### Fuel Hose Abrasion

Engines listed have the potential for fuel hose abrasion at the #1 cylinder where the fuel hose contacts the access cover (see Figure 1). Hoses exhibiting abrasion require replacement. A modified access cover is available to prevent abrasion (see Figure 2).

Figure 1.

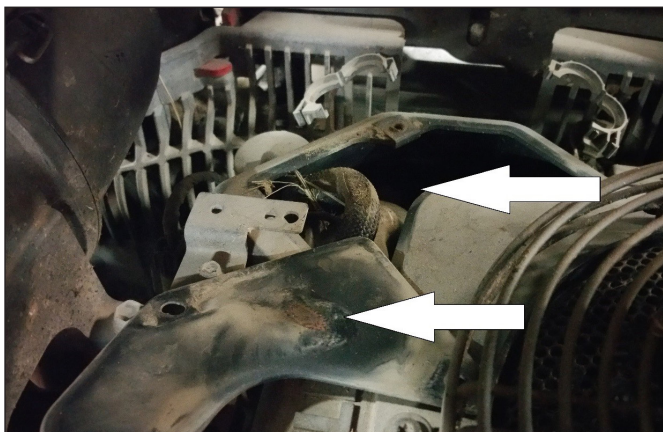
- A. If the abrasion sleeve is not worn through and the fuel hose exhibits no wear from contact, simply replace the access cover only. **Order and install access cover 24 096 168-S.**
- B. If the abrasion sleeve is worn through exposing the fuel hose (see Figure 1), the fuel hose assembly AND the access cover both require replacement. **Order and install fuel hose 24 399 31-S and access cover 24 096 168-S.**
